# SERVICE BULLETIN REVISION NOTICE

NON-MODIFICATION SERVICE BULLETIN - ENGINE - PLATE, RING HPT, STAGE 2 -  
REPLACEMENT OF

Turbojet Engine Service Bulletin No. V2500-ENG-72-0681 Revision No. 2 dated January 9, 2017.

# V2500-ENG-72-0681

LOCATION OF THE STAGE 2 HPT RING PLATE  
FIGURE 1

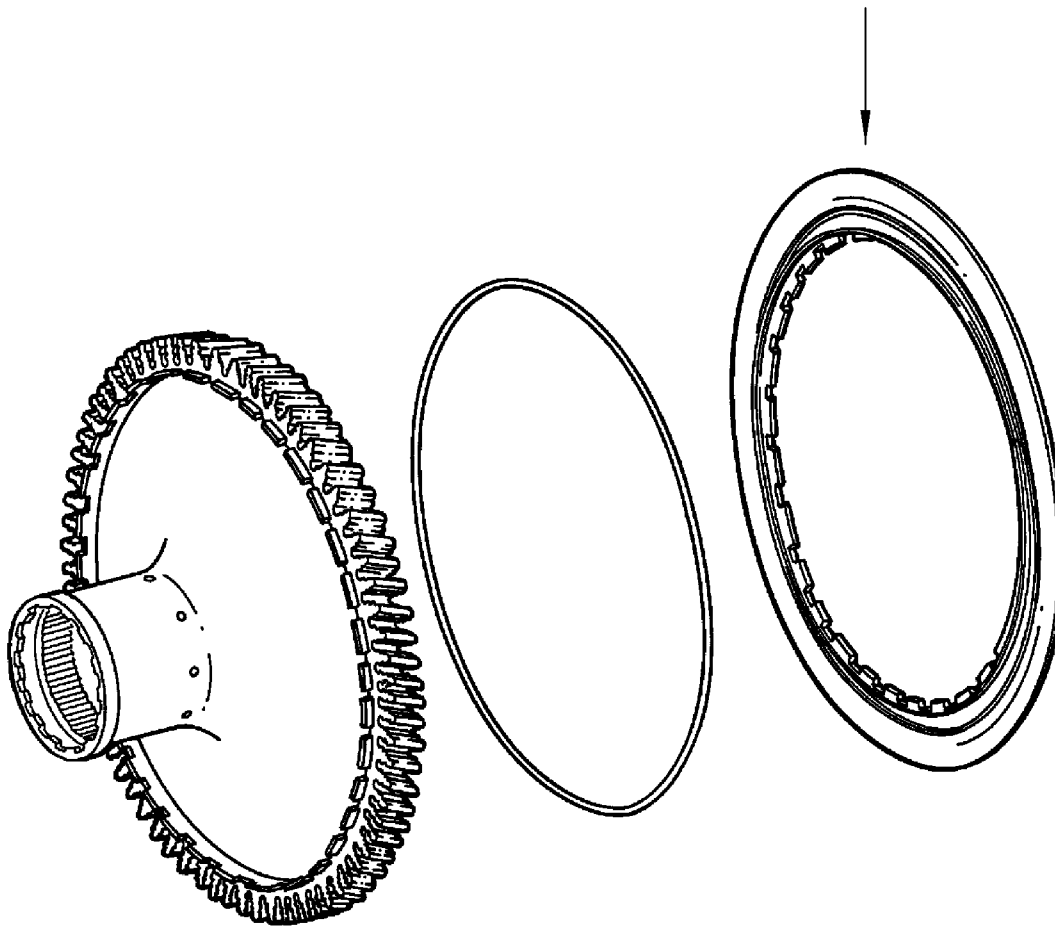
2A3437  
HPT STAGE 2 RING PLATE  
REPLACE AS SPECIFIED IN THE  
ACCOMPLISHMENT INSTRUCTIONS

1. Remove the suspect HPT Stage 2 Ring Plate, PN 2A3437, identified by serial number in Table 1. Reference 5 or 6. Engine Manual, Chapter/Section 72-45-30.
  - A. The HPT Stage 2 Ring Plate, PN 2A3437, identified by serial number in Table 1 must be either returned to IAE or scrapped locally. If scrapped, a photograph or digital image of the mutilated HPT Stage 2 Ring Plate, PN 2A3437, and a copy of the scrap tag, countersigned by the local IAE representative, must be provided to IAE Warranty.
2. Install new non-suspect HPT Stage 2 Ring Plate, PN 2A3437, when assembling the HPT Stage 2 Rotor Assembly. Reference 5 or 6. Engine Manual, Chapter/Section 72-45-30
3. Recording Instructions
  - A. A record of accomplishment is required.
